PHED COMMITTEE #1  
June 22, 2009

TO: Planning, Housing, and Economic Development Committee  
FROM: Glenn Orlin, Deputy Council Staff Director <sup>GO</sup>  
SUBJECT: Germantown Employment Area Sector Plan—transportation elements

**Aircraft Drive/Crystal Rock Drive  
One Way Circulation**

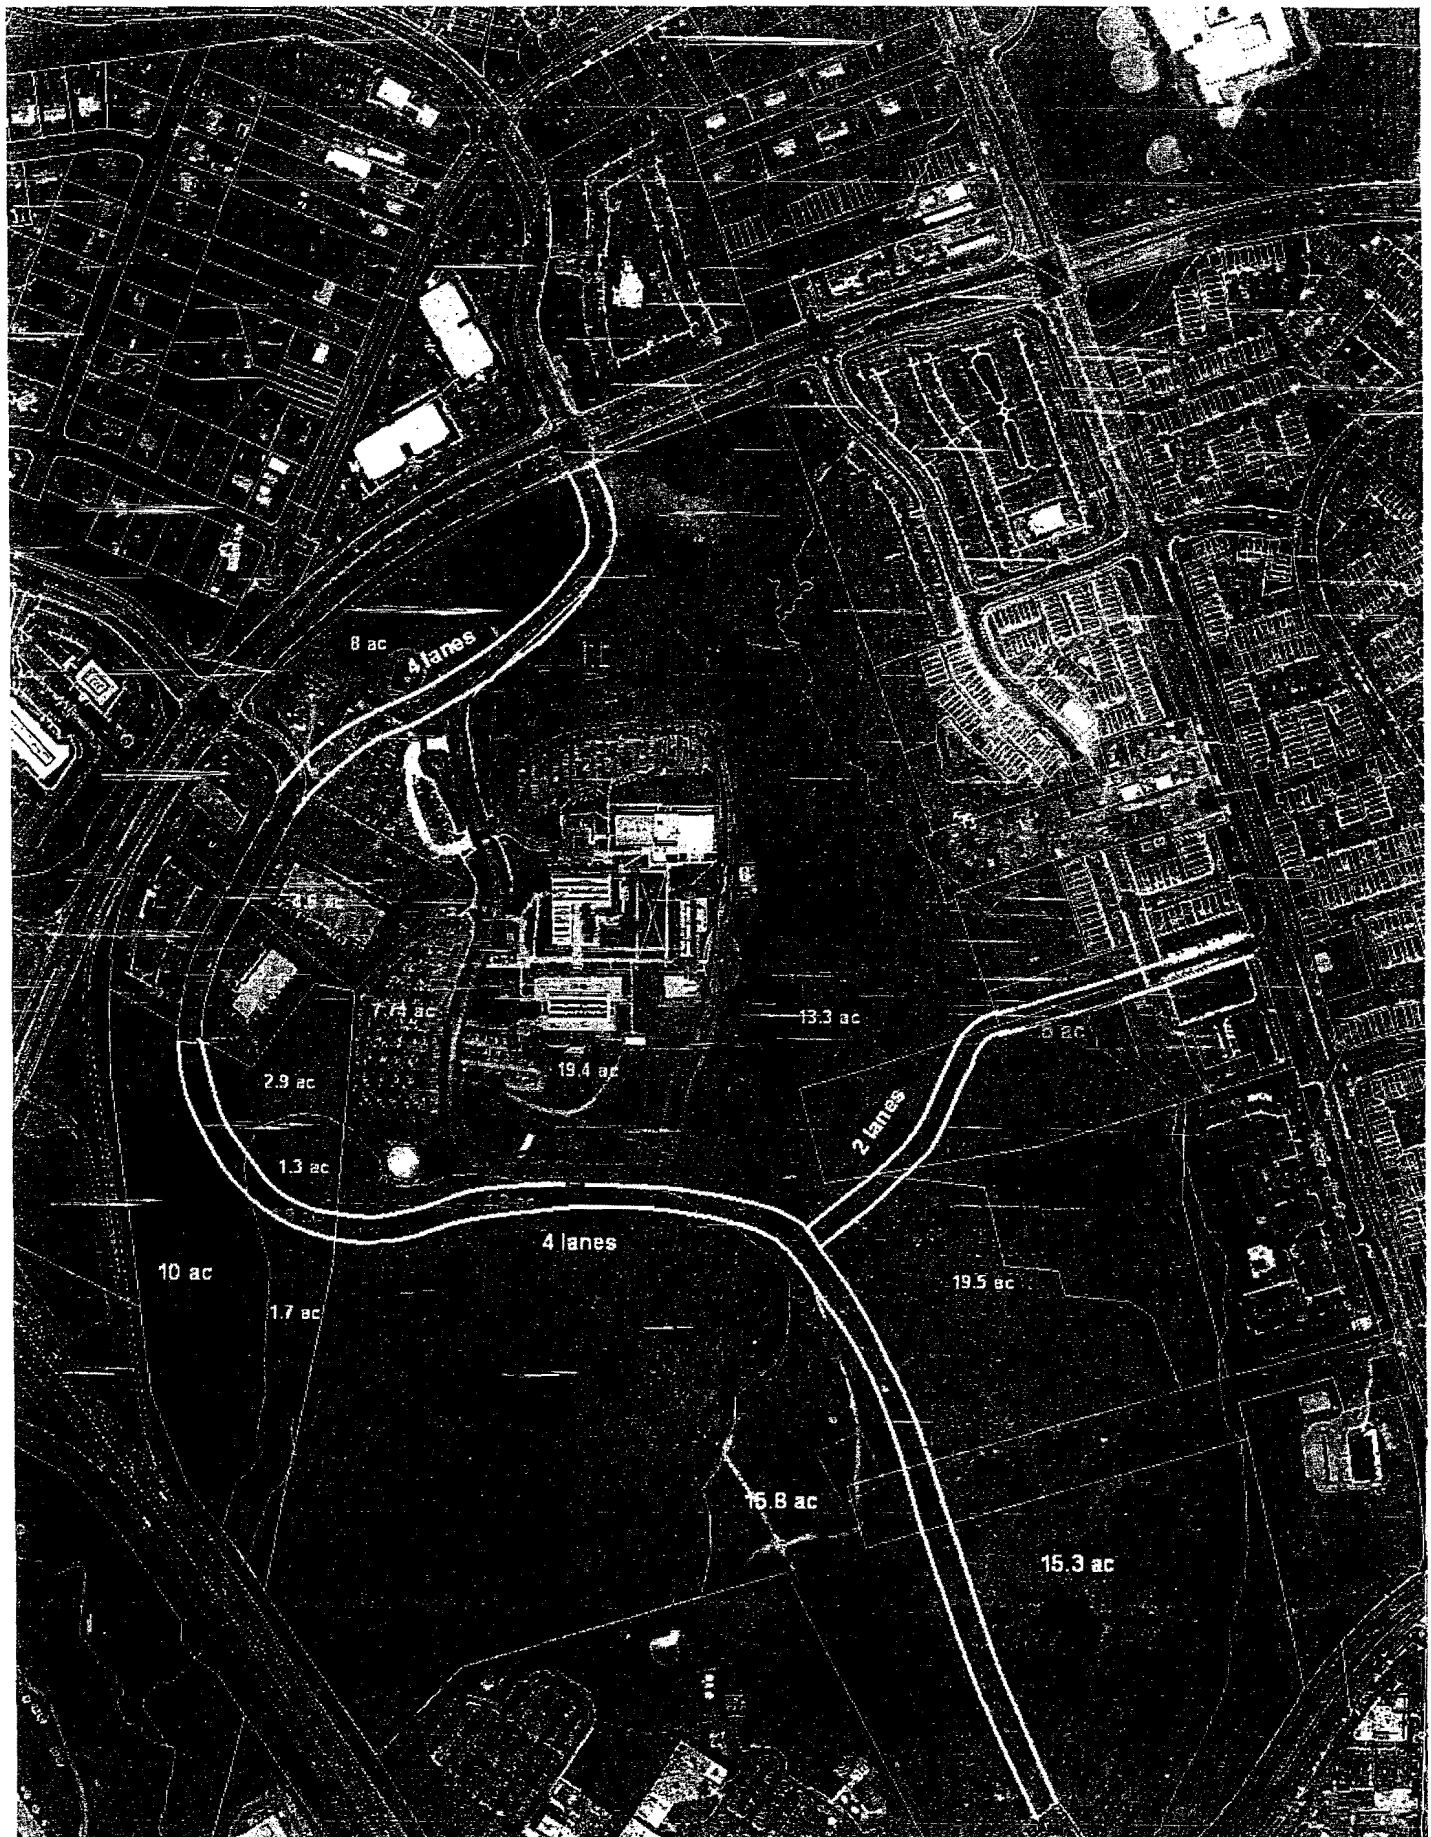
**6. Aircraft/Crystal Rock one-way pair.** The Draft Plan recommends evaluating converting Aircraft Drive and Crystal Rock Drive as a one-way pair through the Town Center area, with Aircraft Drive headed southbound and Crystal Rock Drive northbound (©. DOT opposes any operational recommendation in a sector plan, and it believes that this suggestion may negatively affect the fire and police stations there.

***MCDOT opposes the recommendation to change the circulation pattern at Aircraft and Crystal Rock Drives to one-way couplets as operational recommendations which are outside the purview of Master Plans.*** The Plan recommends operating Crystal Rock Drive as one-way northbound between MD 118 and Aircraft Drive. This is intended to allow for a longer queue for traffic from I-270, as well as bus door access on the right side adjacent to the Transit Center as buses circulate around the Bellmead Property and the transit station. The plan further recommends operating Aircraft Drive as one-way southbound between Crystal Rock and MD 118. This is intended to eliminate additional turning movements on MD 118. MCDOT is concerned about the access and mobility of emergency response equipment from the Town Center Fire Station.

Planning staff's response is that access to and from the police station would be accommodated via driveway access on both Aircraft Drive and Crystal Rock Drive, eliminating the need to circulate around the block. Fire trucks could exit the station on to Crystal Rock Drive, as they do now, and could turn right to head west up Crystal Rock Drive or turn at Aircraft Drive to head east towards MD 118. Another option would be to reposition a fire truck to exit on to Aircraft Drive, thus eliminating the circulation movements completely.

**Council staff concurs with the Final Draft Plan.** Council staff agrees the recommendations about traffic operations are generally not appropriate in master plans, but in

this instance the Draft Plan is only suggesting that the one-way pair must be *evaluated*. There is sufficient rationale to give this matter serious consideration.

**Wildman Property**

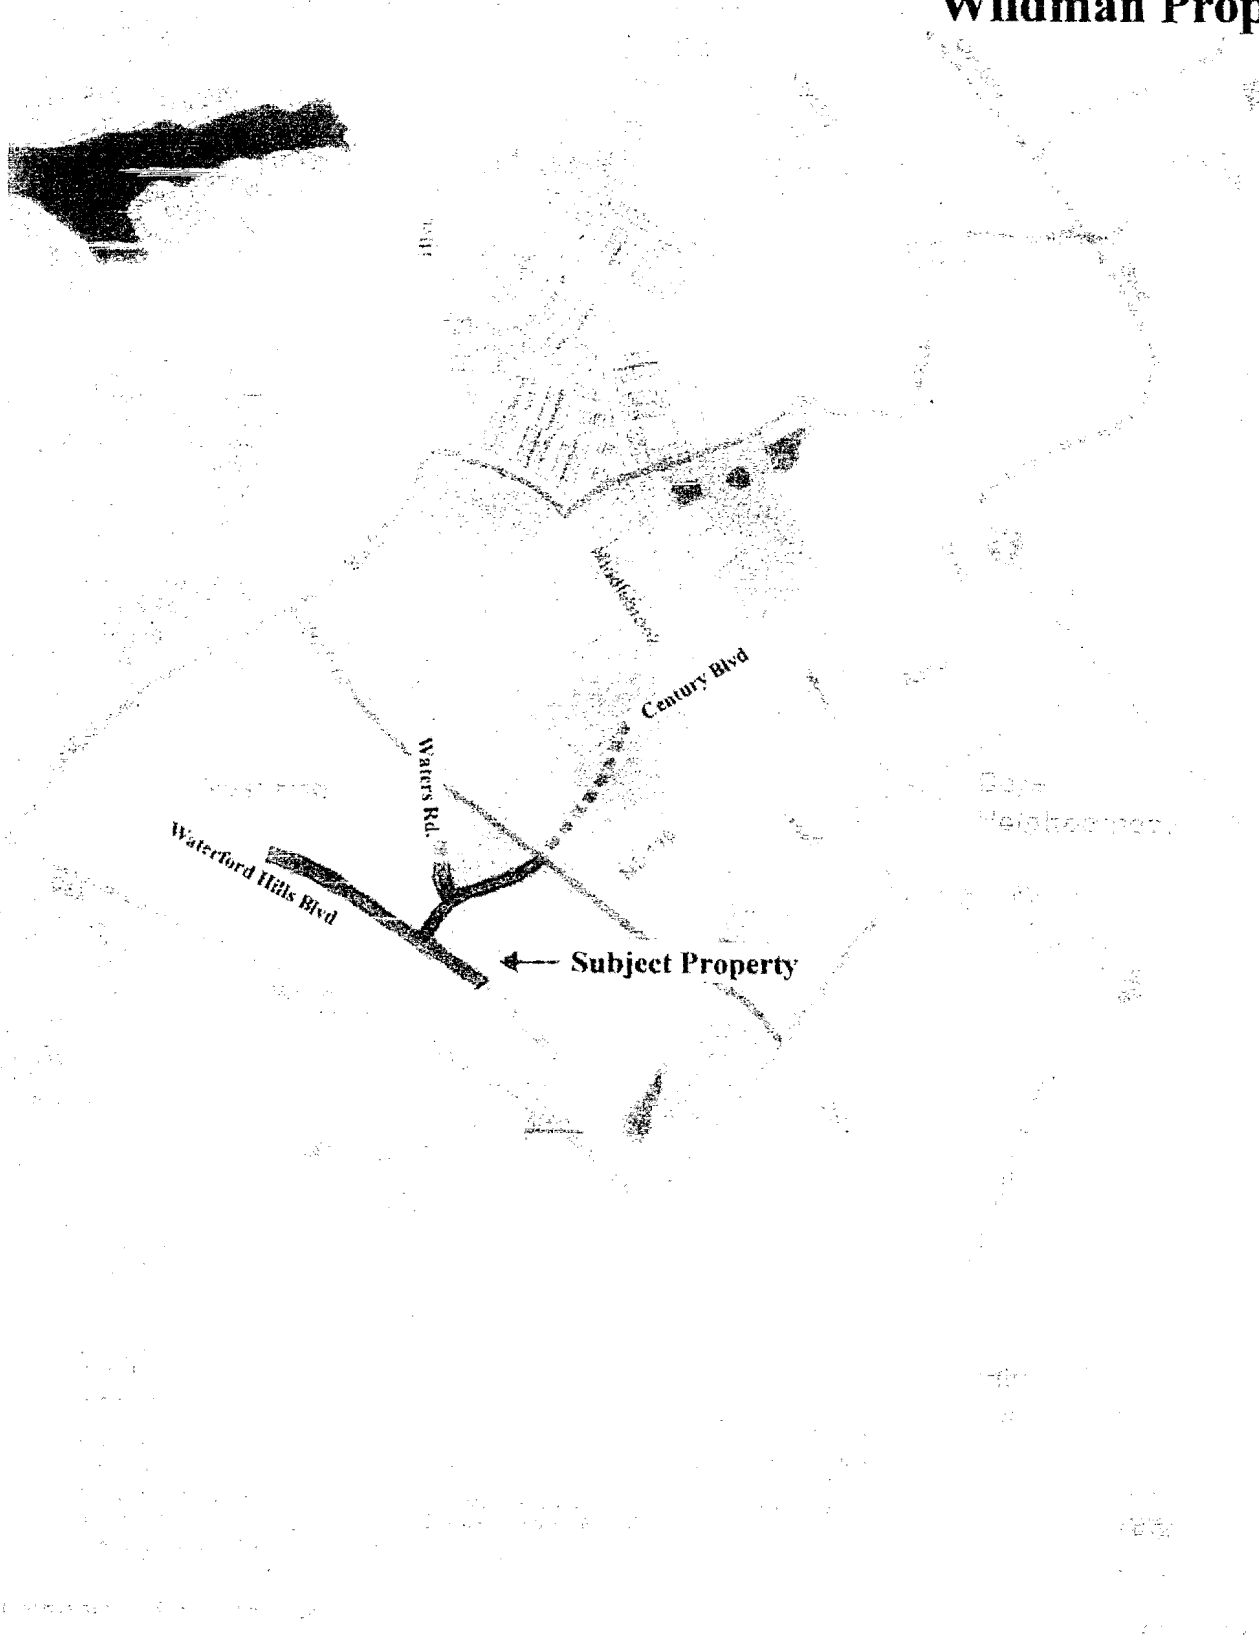
The Sugarloaf Partnership property is proposed for significant redevelopment which will provide the possibility to align Century Boulevard extended on the west side of Wisteria Drive. The Wildman property (1.8 acres) is somewhat affected by the alignment of Bowman Mill Drive with Waters Road. This alignment is deemed necessary to connect with Bowman Mill Drive on the south side of MD 118 and to existing right of way for Waters Road to the north of the Wildman property. Jody Kline, representing Mark Wildman, believes this street pattern severely impacts the property and has prepared an alternative, shown on ©32. **Council staff suggests the Committee hear from both Mr. Kline and Planning staff before rendering a decision.**
